TECHNICAL SERVICE BULLETIN

NUMBER	SD-TSB-122023			TYPE	SERVICE/INSTALL ALERT			
ROUTING	INSTALL	X	ERVIC	X	SALES		PURCH	
TITLE	SST PICKUP SPREADER CHAIN NOISE/WEAR							
REV			ISSUED	12/20/2023		REVISED		
MAY AFFECT	1400601SS/1400801SS/1400100SS/1400150SS/1400200SS/1400250SS ONLY NEWER STYLE WITH BOLT-ON TIE DOWNS

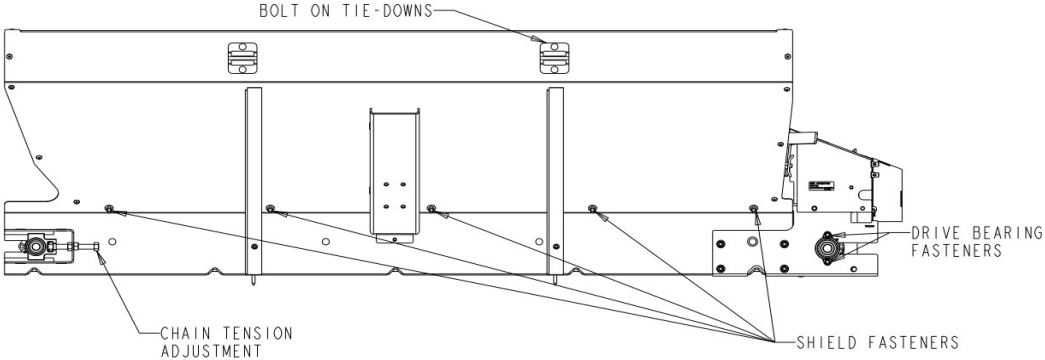
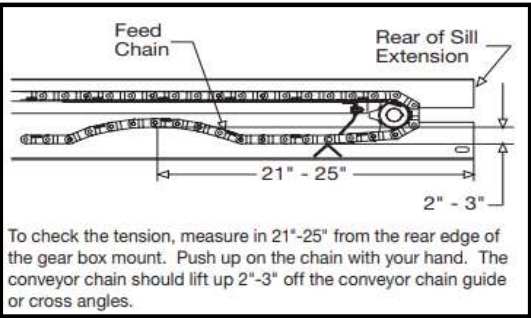
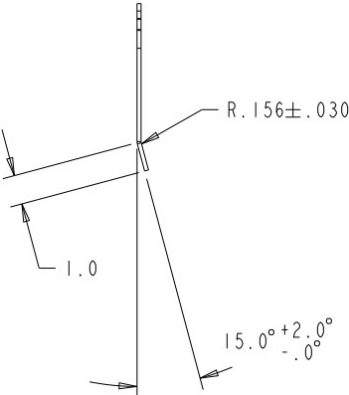
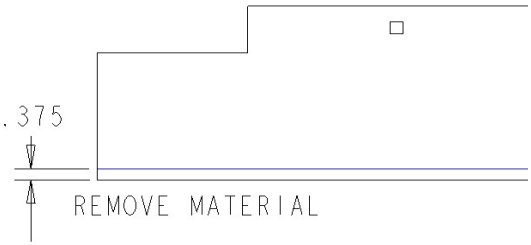
Some SST V-box spreaders built in 2023 may have chain shields that are rubbing against the chain when the spreader is in operation. This can cause noise and increased load on the drive motor when in operation. In extreme cases this can result in damage to the chain. **Some noise as the chain passes over the the end of floor is normal and is not cause for concern and will decrease as the chain stretches naturally.** The main concern is contact between the chain shields and the chain. The shield/chain gap is visible from both the front and rear of the spreader.

NUMBER	SD-TSB-122023	TYPE	SERVICE/INSTALL ALERT
INSTRUCTIONS			
	ADJUST AND BALANCE CHAIN TENSION		
	<p>1. Adjust the chain tension using the idler adjust screws at the front the spreader using the standard instructions shown to the right. It is critical that the chain be tensioned evenly on BOTH sides. Excessive noise may be caused by an overly taugt or unevenly tightened chain.</p>	 <p>To check the tension, measure in 21"-25" from the rear edge of the gear box mount. Push up on the chain with your hand. The conveyor chain should lift up 2"-3" off the conveyor chain guide or cross angles.</p>	
CHECK/CORRECT CHAIN SHIELD CLEARANCE			
<p>2. Check for contact between the chain shields and chain at the rear of the spreader near the chute and at the front of the spreader near the idler shaft.</p>			
<p>3. If the chain is making tight contact with the chain shields, the chain shields should be replaced or may be modified as shown below. This will ensure adequate clearance (>1/8"). Labor may be submitted as part of a warranty claim through normal channels.</p>

<p>Field Modification Option: FORM If the dealer has suitable equipment, the existing shields may be bent to provide the required clearance as shown to the right.</p> 	<p style="text-align: center;">Field Modification Option: SHEAR</p> <p>If the dealer has suitable equipment, the shields may be sheared to remove 3/8" of material from the bottom and reinstalled.</p> 		
<p>8FT REPLACEMENT KIT: 3061351 - 1400601SS, 1400050SS, 1400100SS 7FT REPLACEMENT KIT: 3061352 - 1400801SS, 1400252SS, 1400202SS</p>
